Falcon Highlands South Filing No. 1

Final Drainage Report

SF2418

Active Scenario: 5-year

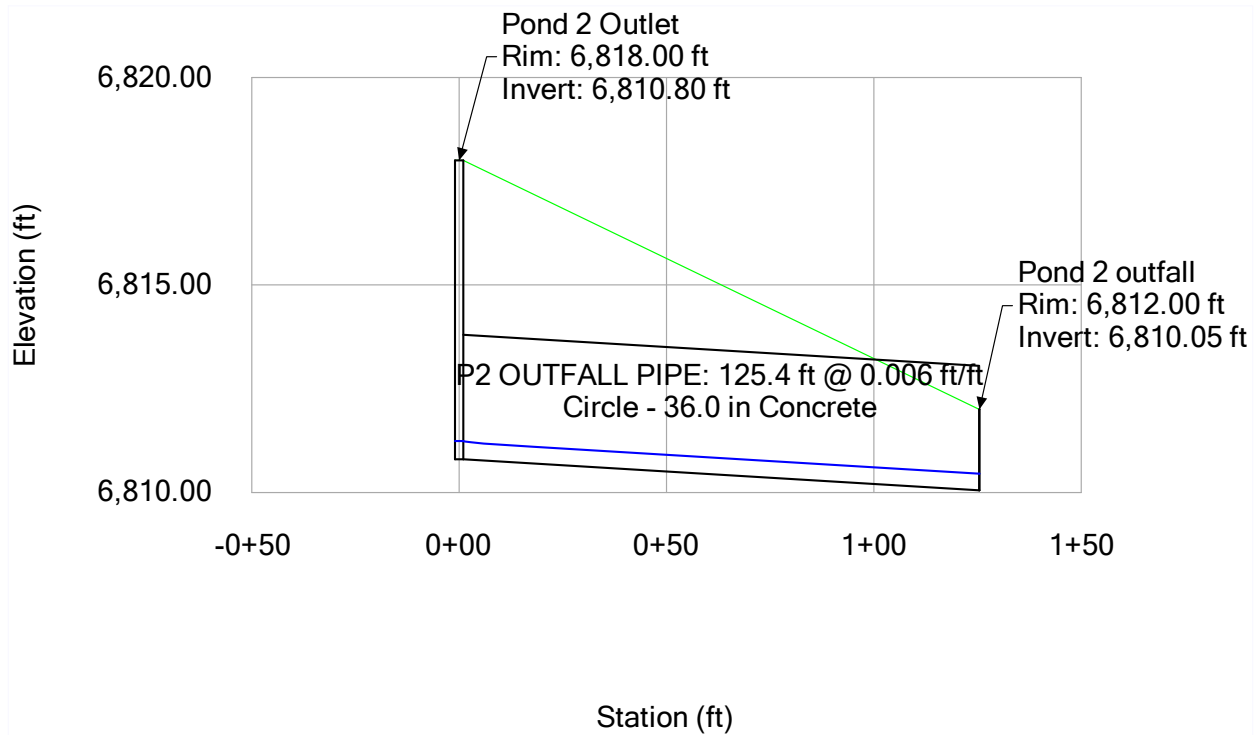
Unresolved Review 6 & 7 comment:
Inconsistencies between stormcad design, conduit table, and CDs.
See version 7 comments on CDs as it appears no updates were made to pipe lengths with this submittal. Please check entire system for accuracy.
It would be helpful if naming convention was consistent between stormcad and CDs.
